Delegated Report	Analysis sheet		Expiry Date:	12/01/2012		
	N/A / attached		Consultation Expiry Date:	1. 15/12/2011; 2. 15/12/2011; 3. 22/12/2011		
Officer		Application Num	ber(s)			
Philip Niesing		1. 2011/5190/P; and 2. 2011/5191/A; 3. 2011/4630/L;				
Application Address		<b>Drawing Number</b>	rs			
281 KENTISH TOWN ROAD LONDON NW5 2JS		Refer to Draft Decision Notice				
PO 3/4 Area Team Signatu	ire C&UD	Authorised Offic	er Signature			
Proposal(s)						
<ol> <li>Alterations to front facade to retail shop (Class A1);</li> </ol>	involving 2x replacer	ment CCTV cam	eras and 1x se	curity alarm box		
<ol> <li>Installation of 2x projecting</li> <li>Alterations to front facade external light fittings and 1</li> </ol>	involving 2x replacer	ment CCTV cam	eras, 2x projec

#### **Site Description**

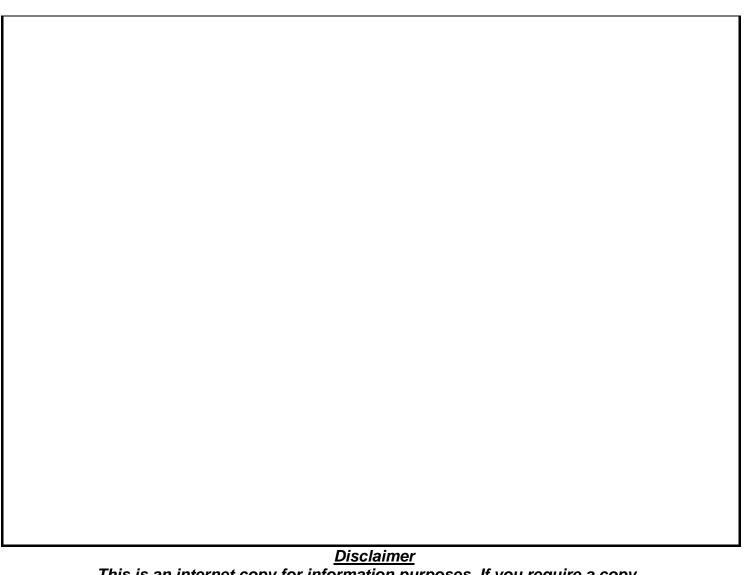
The front façade of the building is relatively narrow, with a shop frontage of 5.6 metres, and it is not considered of adequate width to accommodate two projection signs without causing visual clutter to the detriment of the appearance of the streetscene. Moreover, the building is grade II listed and in accordance with PPS5, policy DP25(g) states that the Council will 'only grant consent for...or alterations... to a listed building where it considers that would not cause harm to the special interest of the building.' It is considered that two projecting signs on this listed building are excessive and would contribute to visual clutter which would materially harm the special historical character and appearance of the listed building and the wider street scene. The impact of the proposed signage would further be exacerbated by the existing signage and other elements proposed on the front elevation, including two CCTV cameras, external lighting to illuminate the proposed projecting signs, a historic black clock at first floor level and a black alarm box sited below the clock.

The above view is considered to be in line with the planning inspectors' when deciding the enforcement appeal. Notwithstanding the designs of the proposed signs, which are an improvement to those considered by the inspector, two projecting signs on this listed building would not overcome the planning inspectors concerns relating to visual clutter and harm to this listed building.

The applicant is informed by means of an informative that the projecting sign on the right may be considered acceptable provided it is painted timber. Ideally if space permits the sign should be raised to fascia level without

Two small light fittings would be attached at first floor level to light the projecting signage. These would be small in size and coloured black and generally considered acceptable. However, since the proposed projecting sign on the left are considered excessive and unacceptable in visual terms, the light fitting proposed for its illumination sited between the traditional pawnbroker sign and the proposed CCTV camera would be pointless and cause unnecessary visual clutter. The applicant is that for the proposals to be acceptable the subject light fitting, i.e. the one on the left together with the projecting sign needs to be omitted.
